# PROPOSED SUBDIVISION OF LOT 1 SEC. 6 TP. 26 O.D.Y.D. PLAN 9339

This forms part of application  
# Z16-0060

**Subject:** 4039 Lakeshore Rd

**Date:** October 24, 2016  
**File No.:** S16-0047  
**To:** Community Planning (TH)  
**From:** Development Engineering Manager (SM)  
**Subject:** Subdivision Application – PLR Requirements

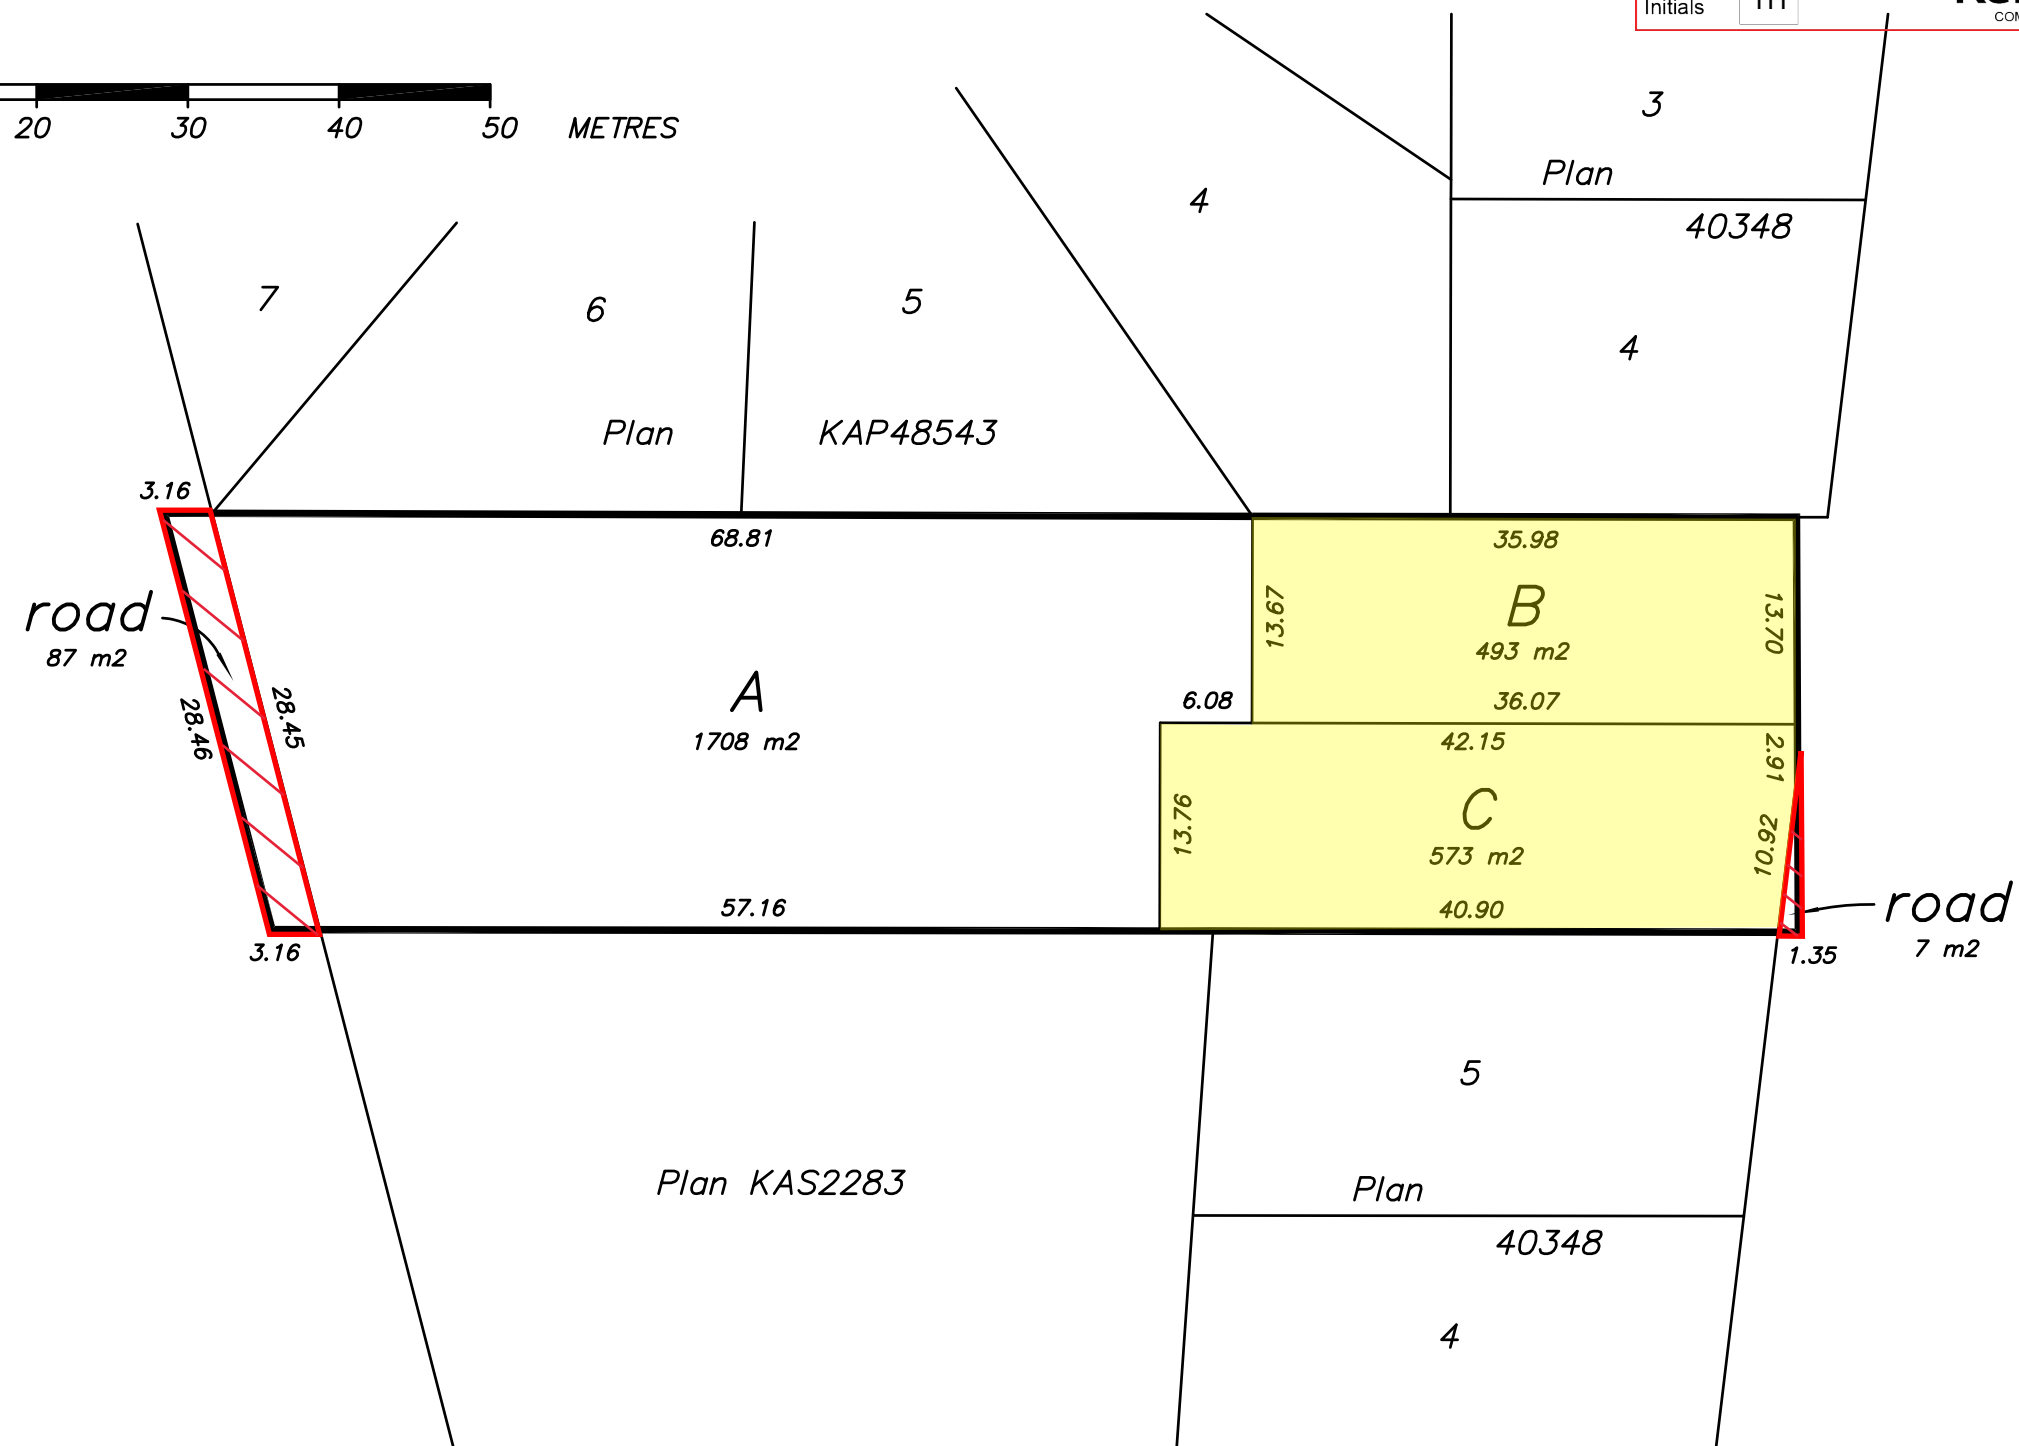
- a) The property is located within the City of Kelowna service area. The existing PVC water service will need to be upgraded to a 19mm copper service for the Lakeshore Rd lot.
- b) New water services can be provided for the Belmont Rd lots at the applicant's cost prior to subdivision approval. **The applicant will be required to sign a Third Party Work Order for the cost of the new service requirements.** For estimate inquiry's please contact Sergio Sartori at [ssartori@kelowna.ca](mailto:ssartori@kelowna.ca) or phone 250-469-8589. Or arrange for lot connections before submission of the subdivision plan.

- a) The Lakeshore Rd lot is serviced with a 100mm diameter service which is acceptable. New sanitary services can be provided for the Belmont Rd lots at the applicant's cost prior to subdivision approval. **The applicant will be required to sign a Third Party Work Order for the cost of the new service requirements.** For estimate inquiry's please contact Sergio Sartori at [ssartori@kelowna.ca](mailto:ssartori@kelowna.ca) or phone 250-469-8589.

- a) Lakeshore Road frontage must be upgraded to a full urban standard including curb, gutter, sidewalk, fillet pavement, street lights, storm drainage, landscaping and adjustment and/or re-location of existing utility appurtenances if required to accommodate this construction.
- b) Belmont Road frontage must be upgraded to a full urban standard including sidewalk and adjustment and/or re-location of existing utility appurtenances if required to accommodate this construction.
- c) Re-locate existing poles and utilities, where necessary.

- a) Dedicate ~3.2m width along the full frontage of Lakeshore Rd. the existing fence and gate post must be removed.
- b) Dedication on Belmont Rd to adjust property line to match existing adjacent properties.
- c) Grant statutory rights-of-way if required for utility services.
